Item: 145kV IVT

Customer: APTransco, Andhra Pradesh

List of Standard Drawings/Documents:

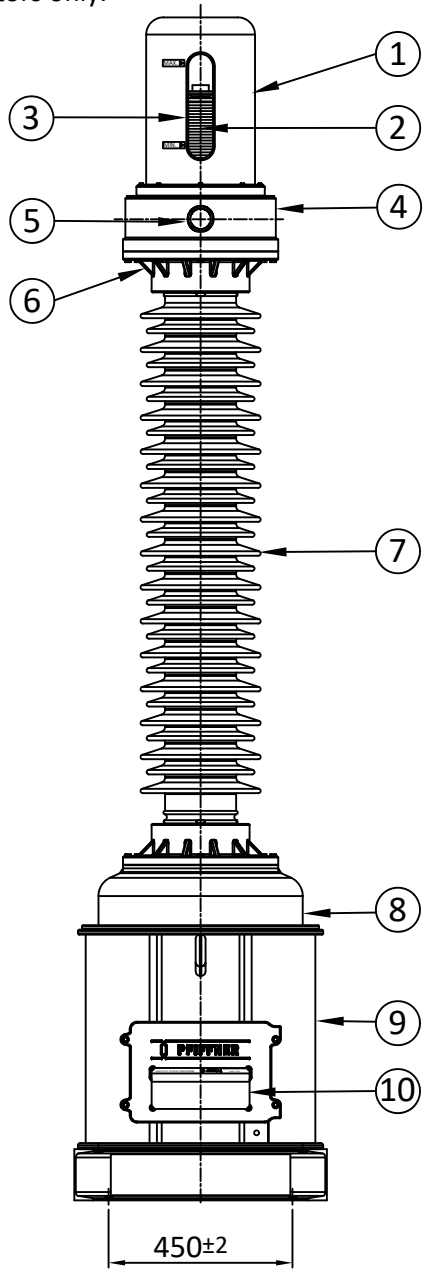
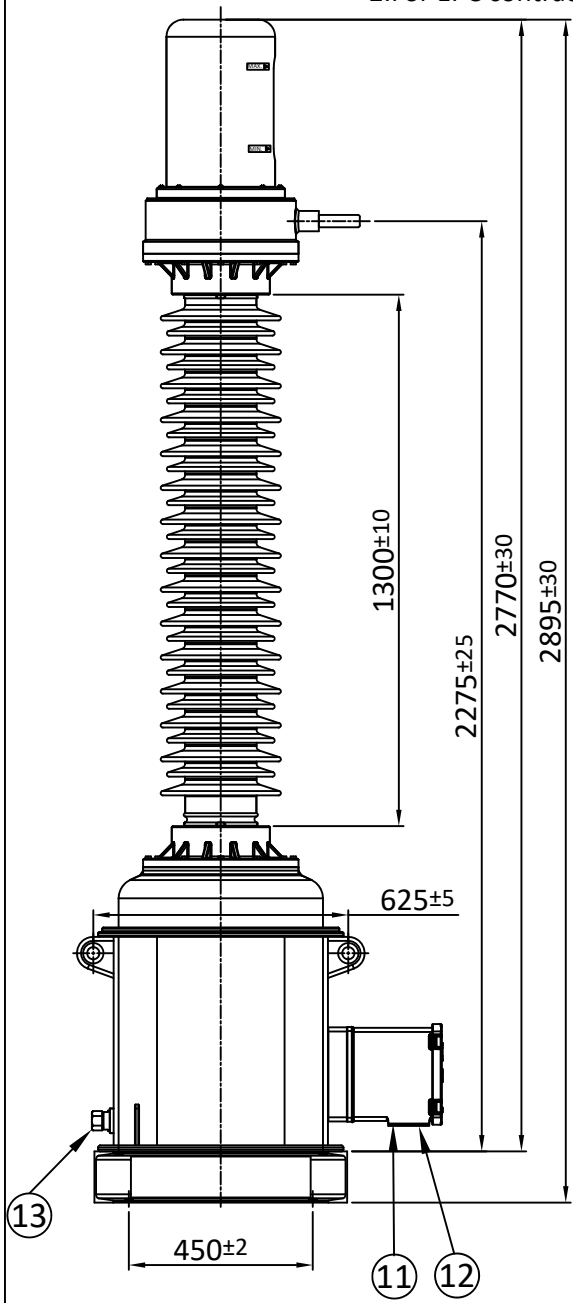
1. Minimum 300mm plinth shall be maintained for CT/PT/CVT/ Isolators/IVT in the substation during foundation works to ensure safe live to ground clearance as per IE rules.
2. Since the supply of terminal connectors is not in the scope of manufacturers as mentioned in the drawings. The EPC contractors shall be instructed to supply the same in line with CT/PT/CVT/Isolator /IVTs requirement and capability.

NOTE:-1. Drawings approval subject to valid type test reports,

to be checked during acceptance tests.

2. For EPC contractors only.

Drawing approval subject to valid vendor registration

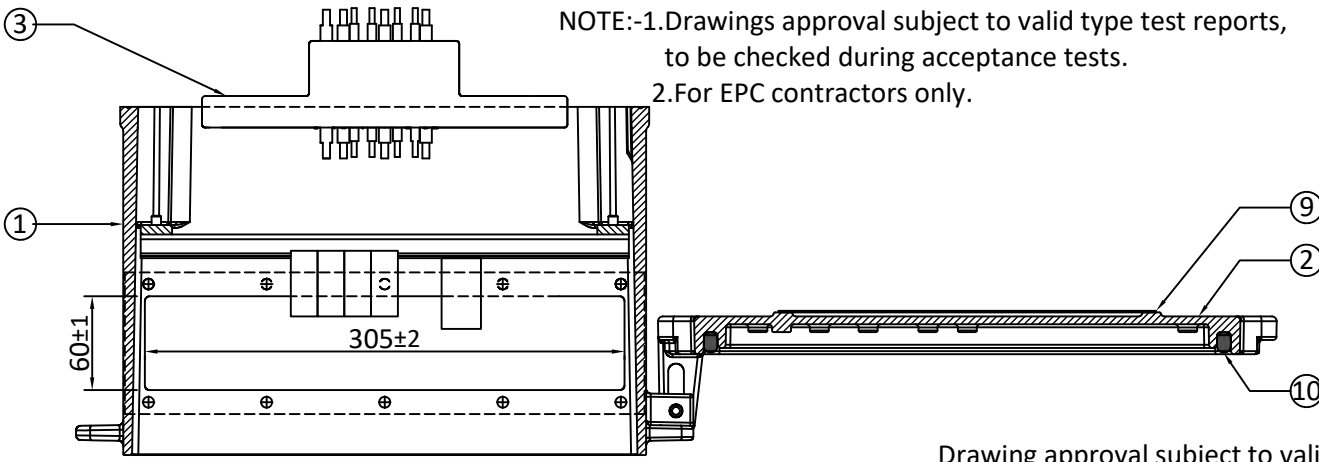
1. Minimum 300mm plinth shall be maintained for CT/PT/CVT/ Isolators/IVT in the substation during foundation works to ensure safe live to ground clearance as per IE rules.
2. Since the supply of terminal connectors is not in the scope of manufacturers as mentioned in the drawings. The EPC contractors shall be instructed to supply the same in line with CT/PT/CVT/Isolator /IVTs requirement and capatibility.

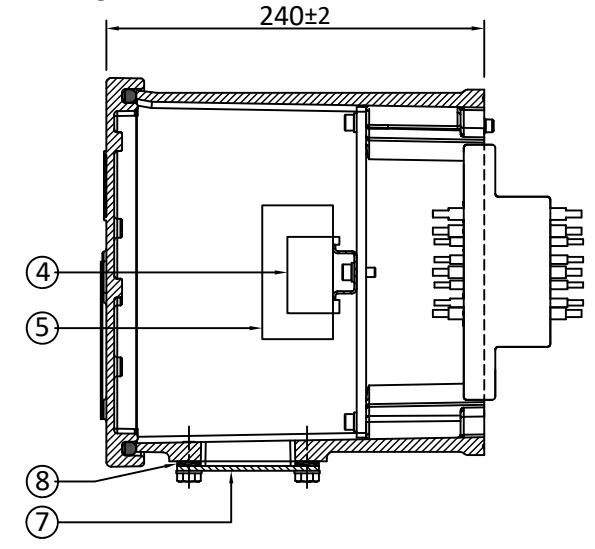
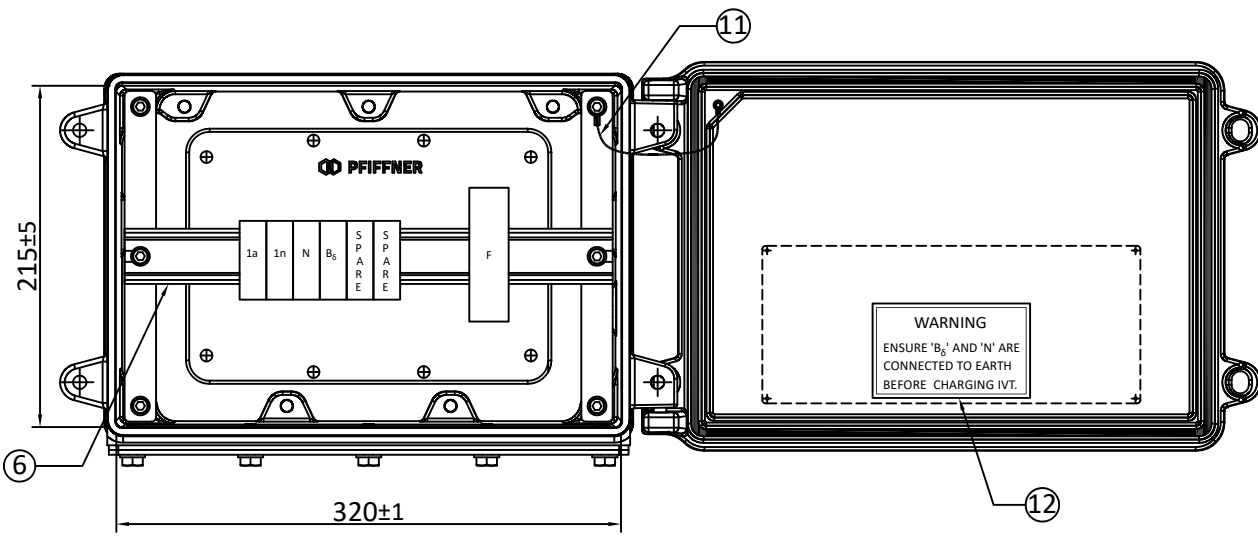
NOTE:-1. Drawings approval subject to valid type test reports, to be checked during acceptance tests.
2. For EPC contractors only.

Drawing approval subject to valid vendor registration

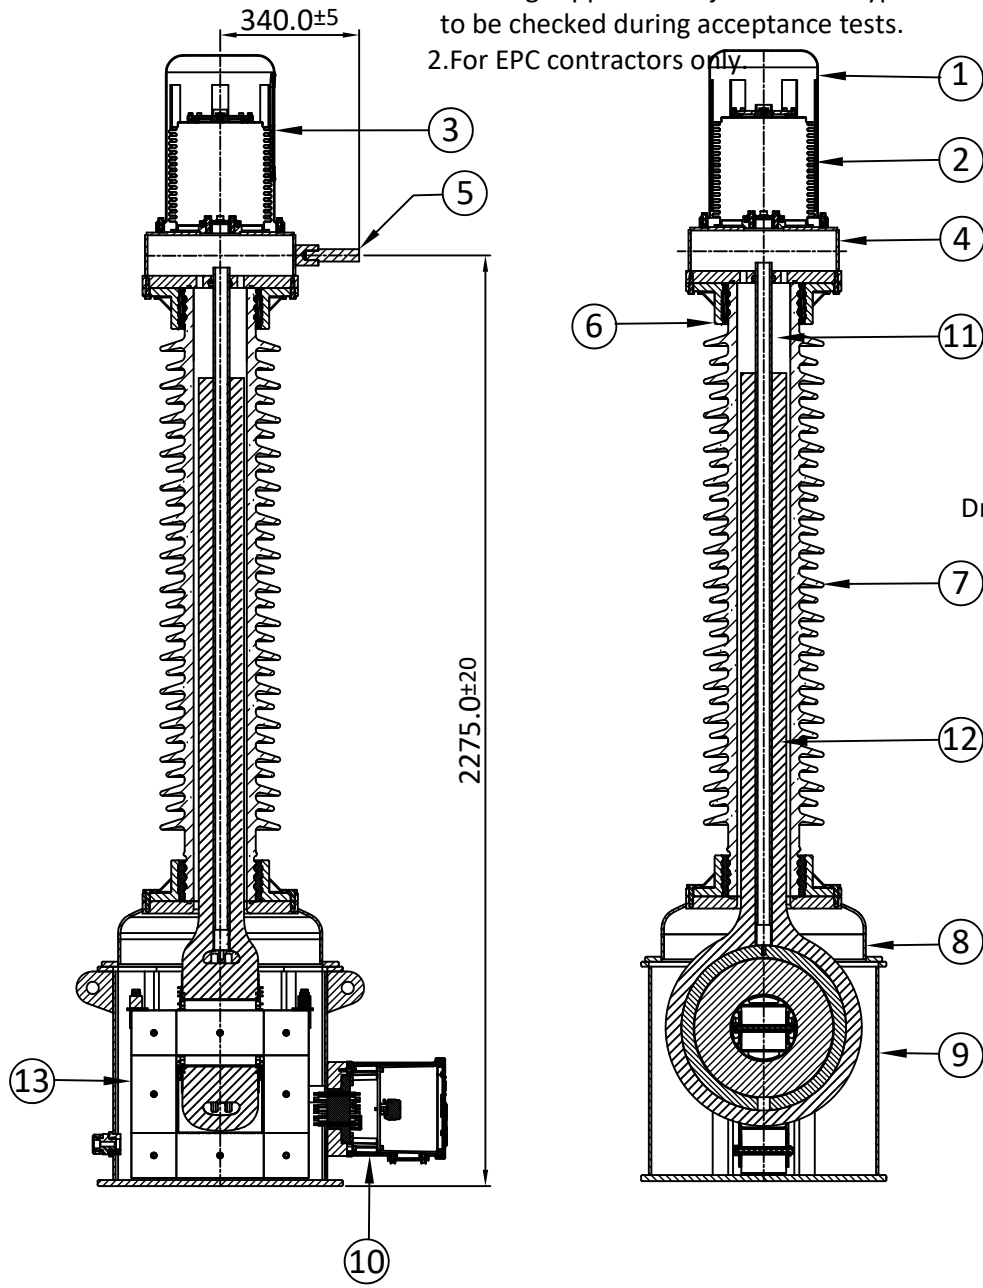
NOTE:-1. Drawings approval subject to valid type test reports,
to be checked during acceptance tests.
2. For EPC contractors only

Drawing approval subject to valid vendor registration
